CITY OF ALBUQUERQUE

**RE: U-Haul
8200 Jefferson Street NE
Conceptual Grading and Drainage Plan
Engineer's Stamp Date: No Stamp Date
Hydrology File: C17D146**

80% Stormwater Management Report

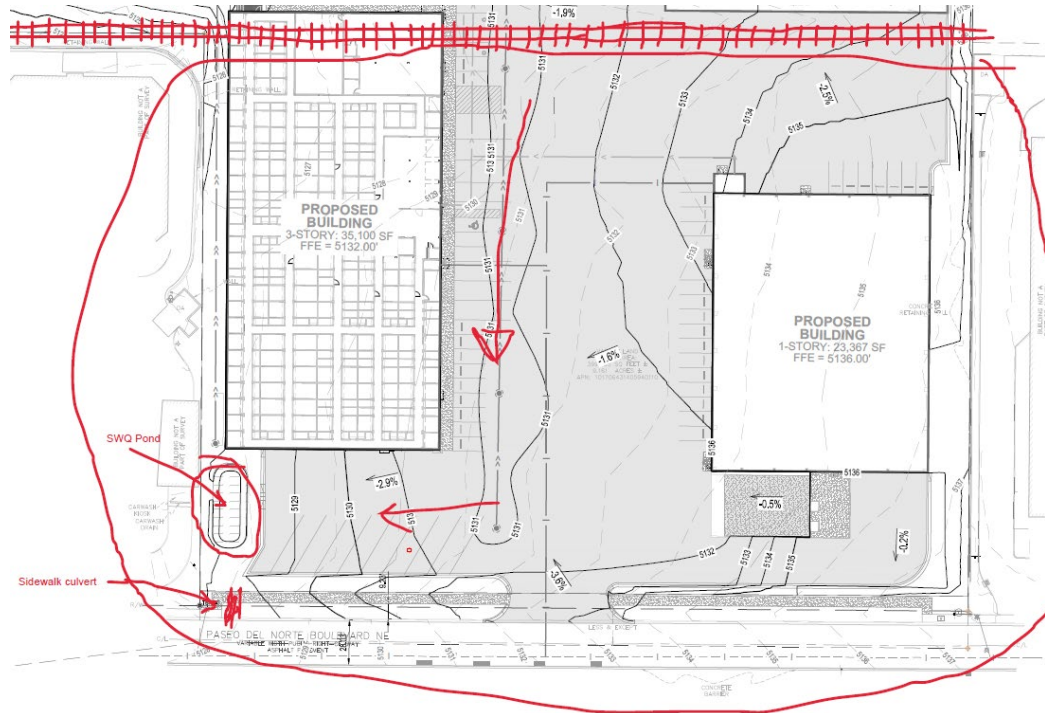
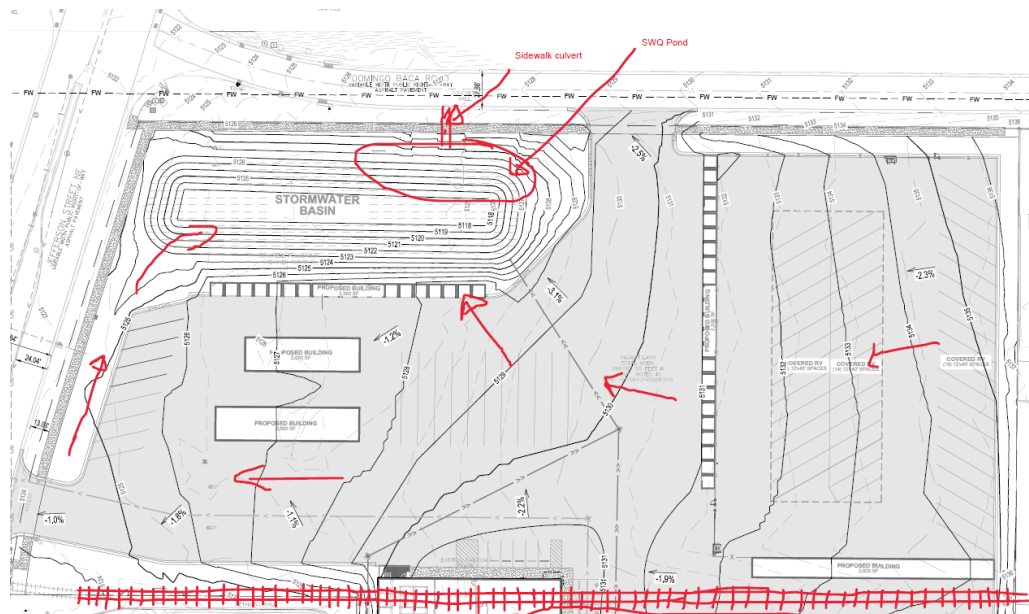
- Since there is an existing railroad spur through the site as indicated in Comment #4, the site will have two separate drainage discharge points. The southern portion drains to a Stormwater Quality Pond with an emergency spillway as a sidewalk culvert to Paseo de Norte Access Rd.

The northern portion drains to a Stormwater Quality Pond with an emergency spillway as a sidewalk culvert to Domingo Baca Rd.
